March 10, 2023  
L-23-085

Perry Nuclear Power Plant  
Docket No. 50-440, License No. NPF-58  
EMERGENCY PLAN FOR PERRY NUCLEAR POWER PLANT DOCKET No. 50-440

### Perry Nuclear Power Plant EP 0000 Revision 61 Change Summary

FIGURE 7-3 - OPERATIONS SUPPORT CENTER (OSC) LAYOUT

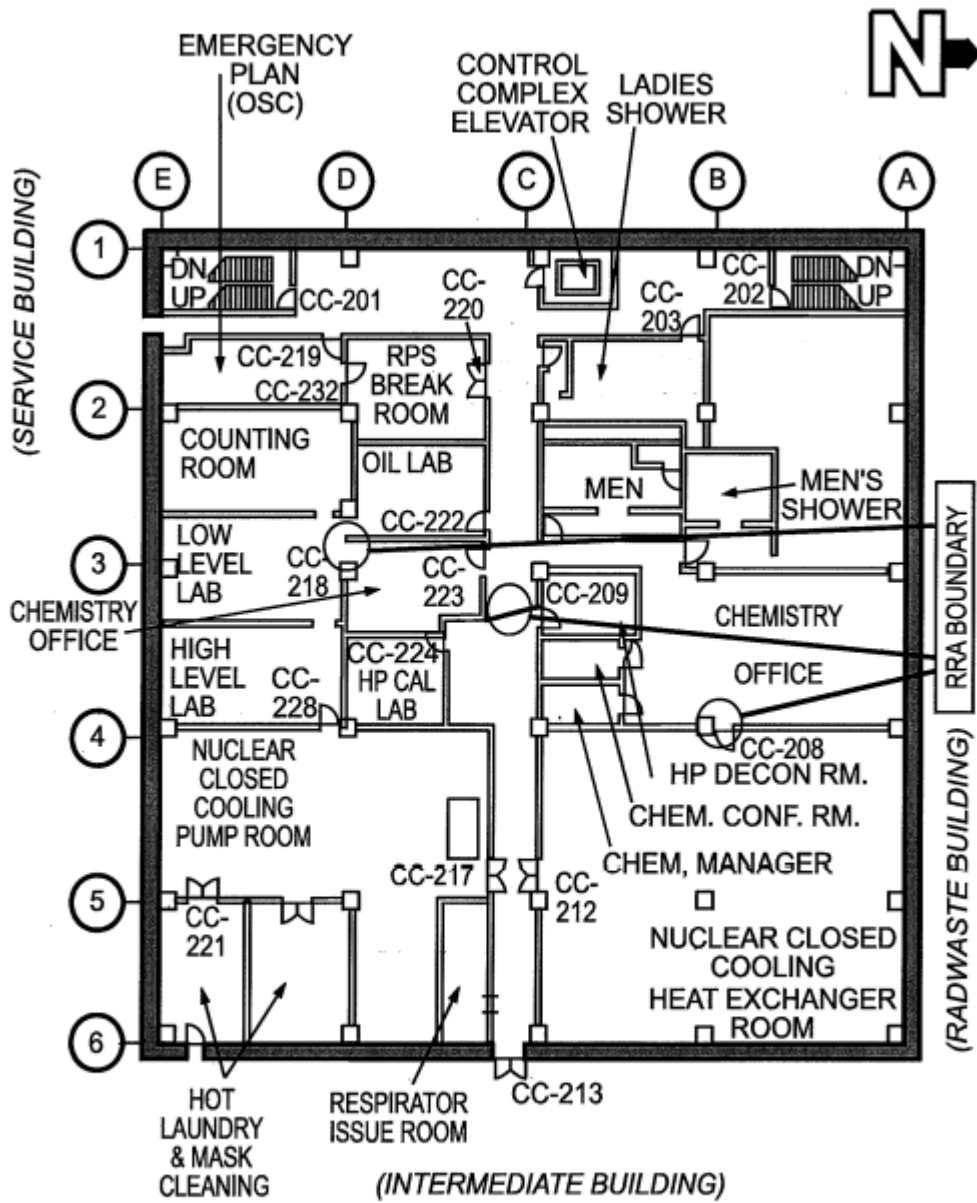
3. Figure 7-3 OSC Layout updated to the current CC599 OSC Layout.
  4. Section 5.2.2.4 Underlined Dose Assessment Coordinator.
  5. Section 5.2.2.1 STA section updated for clarification of responsibility to perform dose assessments.
